ADDENDUM

Matilda Torres High School Stadium Signage
Madera, CA 93637

DARDEN PROJECT NO. 2163
DSA File Nos. 20-30
DSA APPL. NO. 02-121740

END OF ADDENDUM 01

A1.02

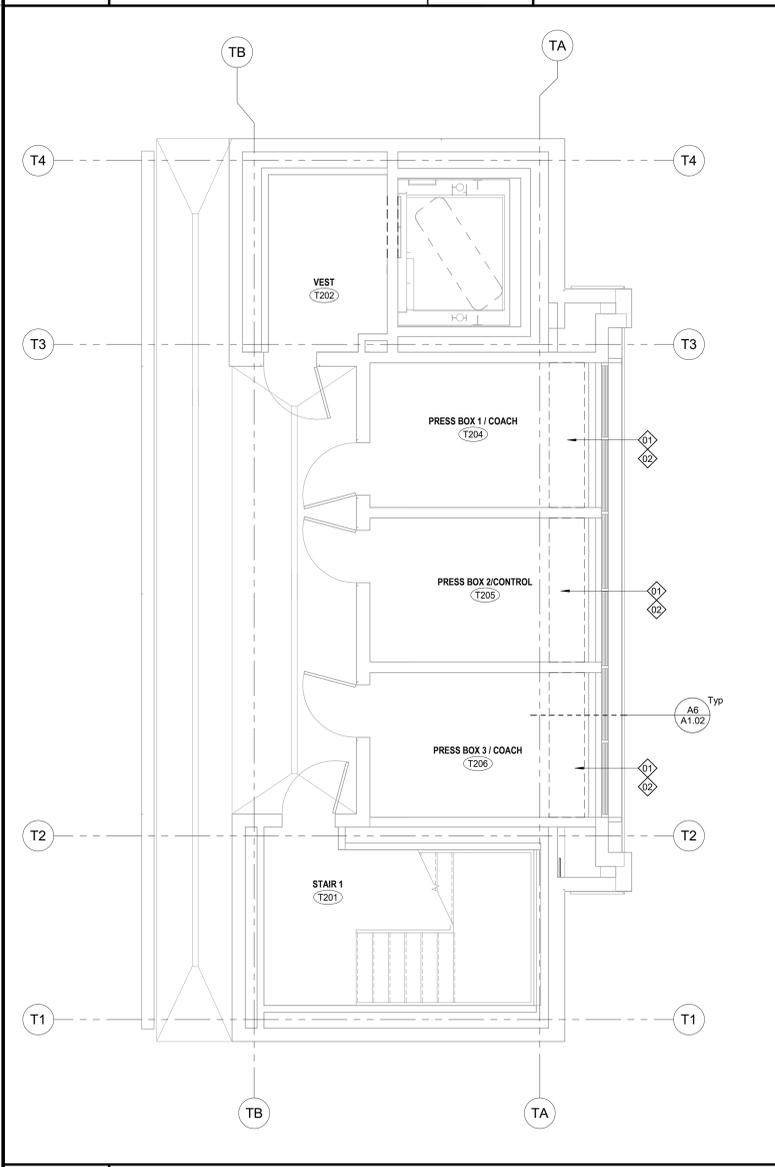
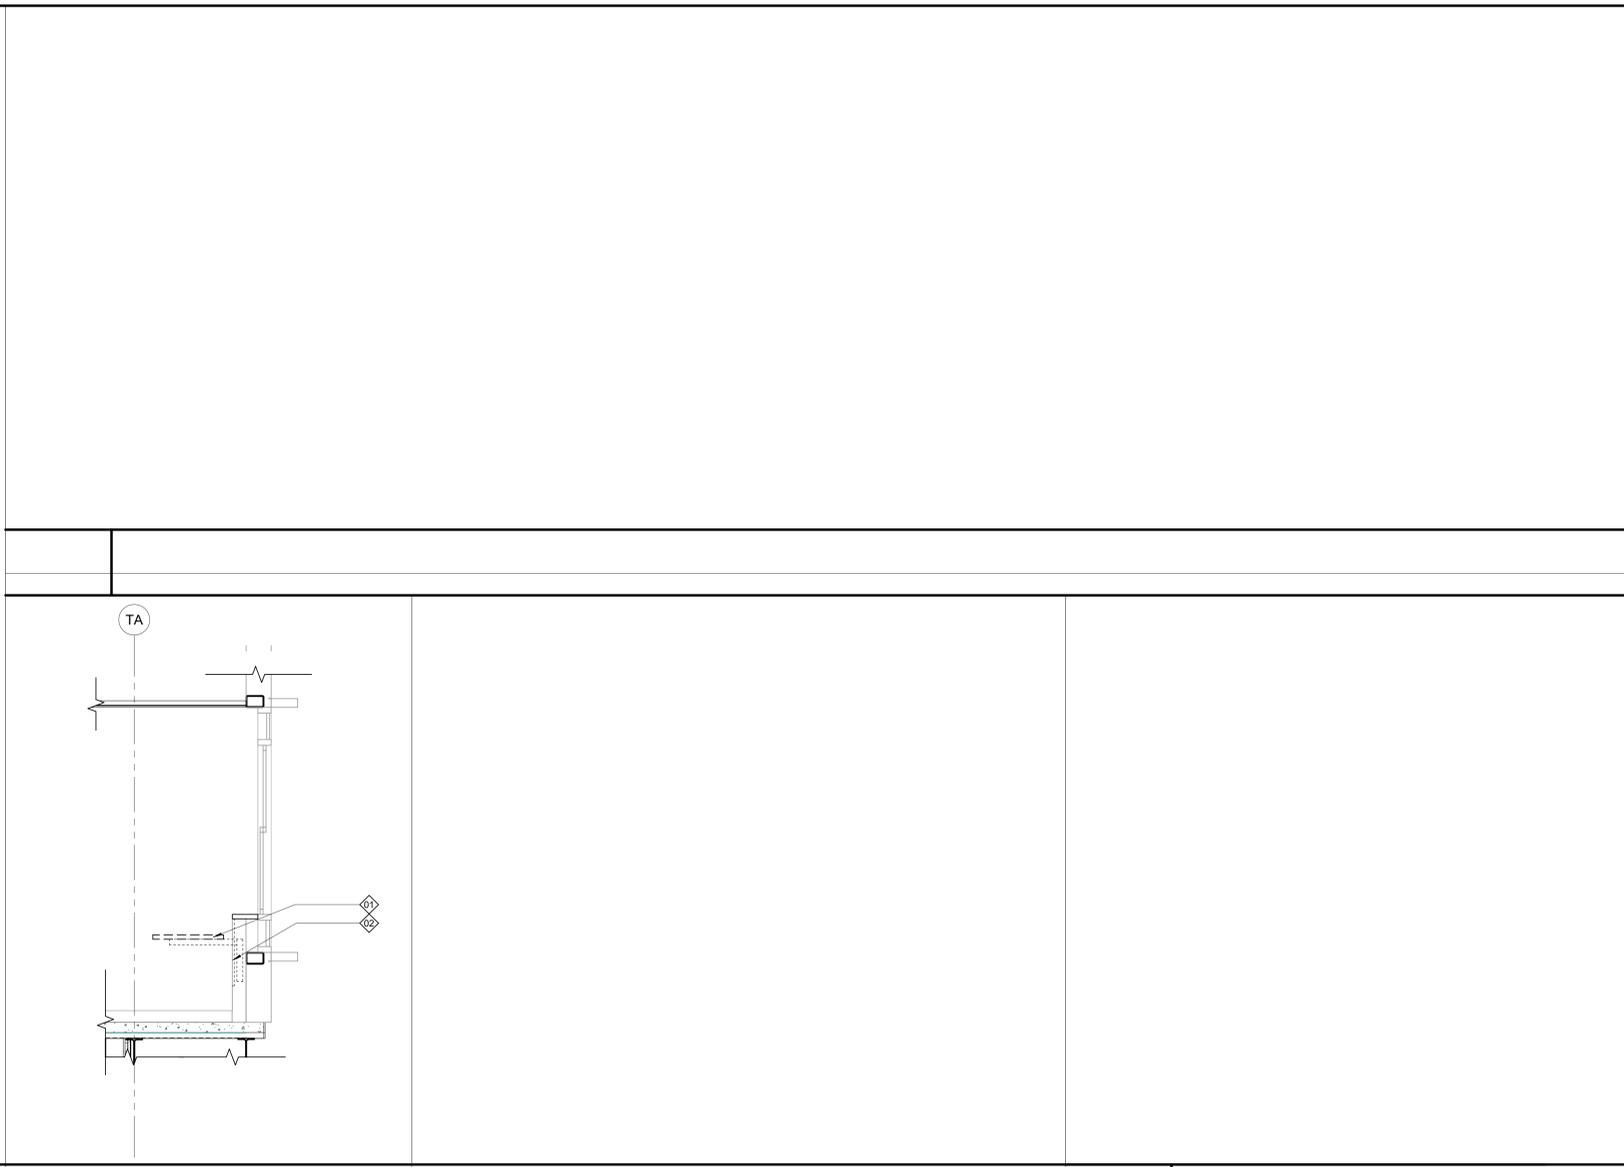
1. Insert sheet A1.02 COUNTERTOP DEMO into set
 - a. sheet indicates removal of press box counter tops

- 01 SELECTIVE DEMOLITION. Remove and Salvage to Owner, Existing Casework countertops and wall brackets
- 02 SELECTIVE DEMOLITION. Remove and Dispose portion of Existing wall to allow for removal of counter top support brackets. Patch back and repair dry wall to original state
- 03 SELECTIVE DEMOLITION. Remove gates from posts for reinstallation after stiffener plates have been installed
